**RICHARDSON FLATS TAILINGS SITE
SUMMIT COUNTY, UTAH
TDD #T08-9207-019**

**TAT Response to Pioneer Technical Services, Inc.
Comments and Observations Report
Dated July 13, 1992**

FIGURE 1
WELL AND LANDFILL
LOCATION MAP

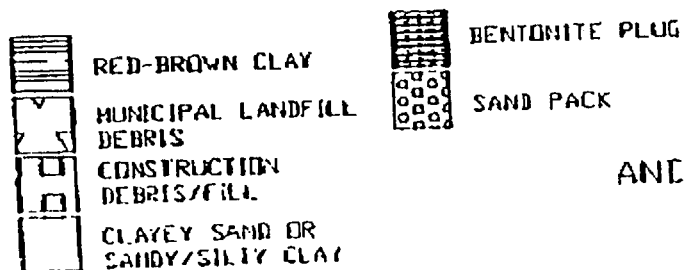
The most blatant violation of EPA guidance in the drilling of these monitoring wells was the placement of well MW-2 within the boundary of the historic landfill (see Figure 1). USEPA direction is clear - drilling directly through municipal landfills is to be avoided in order to protect underlying groundwater, and for obvious safety considerations; rather, drilling is to be conducted off of the actual landfill and downgradient from it. Prior to drilling, the TAT was advised by the property owner (UPCM) that the location selected for MW-2 was within the former landfill boundary. For whatever reasons, the TAT declined to relocate the well 100 feet to the north, out of the former landfill. After drilling five to ten feet, drill cuttings and split-spoon sample cores showed that the borehole was obviously within the landfill.

- well logs; a plan of the ~~the~~ site prepared by PTS which

places the monitoring wells at different distances from each other than does the ~~the~~ PTS cross-section.

Contrary to statements made by the consultant, there are no references in EPA guidance or State of Utah administrative regulations prohibiting drilling in landfills. TAT believes that well RF-MW-02 is actually located in an optimum location in order to detect leachate emanating from beneath the landfill.

FIGURE 2
GEOLOGIC CROSS SECTION
AND LANDFILL MONITORING WELLS

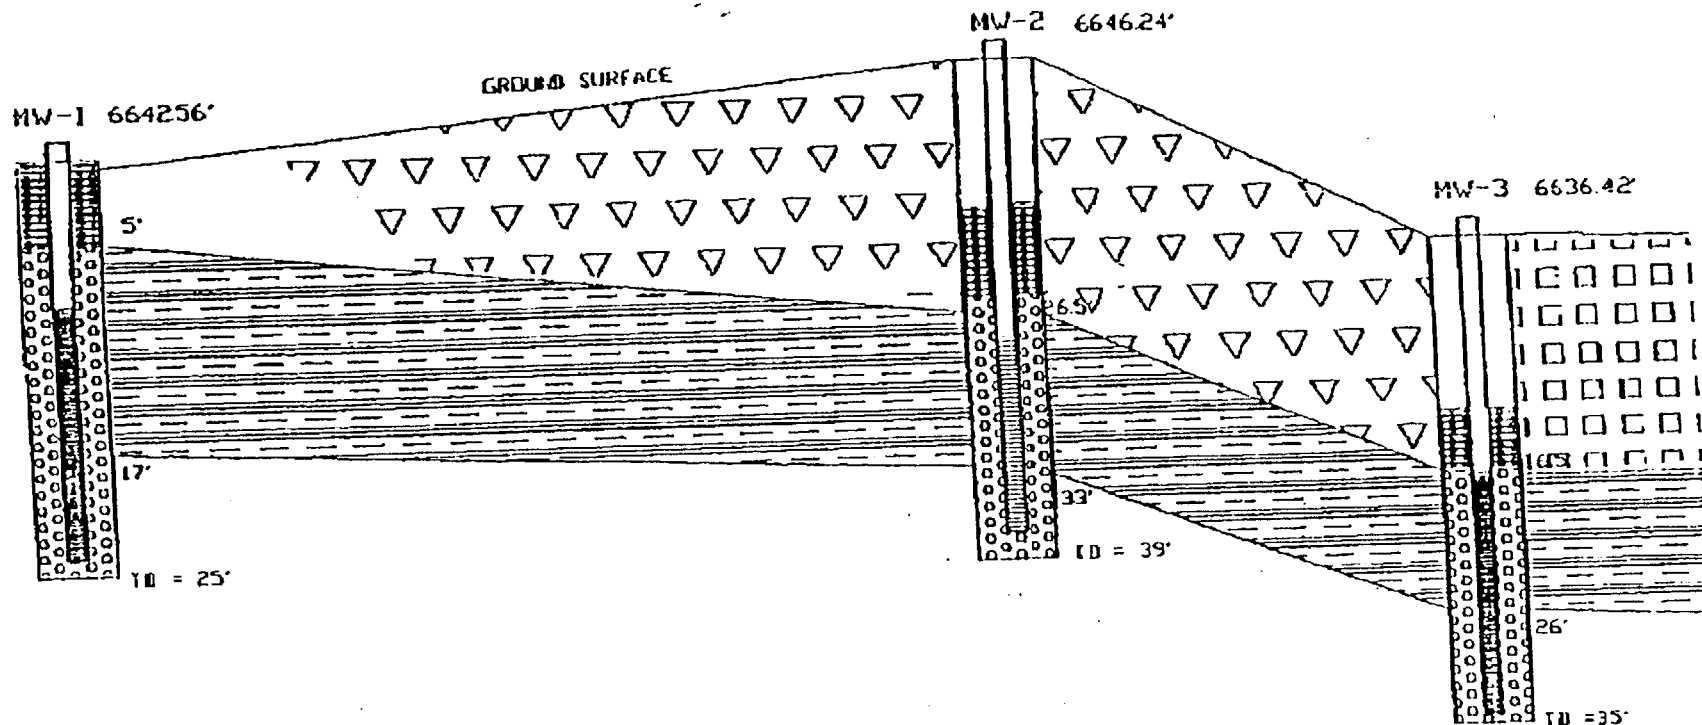
- geologic conditions observed during logging by the TAT, and those described by PTS in their text; the preparation of a cross-section by PTS

which is not compatible with well logs prepared

by the TAT and not substantiated by any alternative

- a claim by PTS that water in MW-02 will "flood" the landfill, coupled with the assertion that the water in MW-02 rose to "exactly 26.5 ft bgs" (below ground surface), while at the same time they assert that the split-spoon sample from 25-27 ft bgs in MW-02 ^{was} "clearly" showing the top of the aquitard to be at 26.5 ft bgs."

The cross-section of the landfill which I have prepared (see attachment), implies that the elevations of water in the three monitoring wells are compatible with the interpretation, that they are

installed into an unconfined aquifer within a predominantly clay unit containing lenses and stringers of sand and gravel. Please check that the elevations and distances agree with your own surveys.
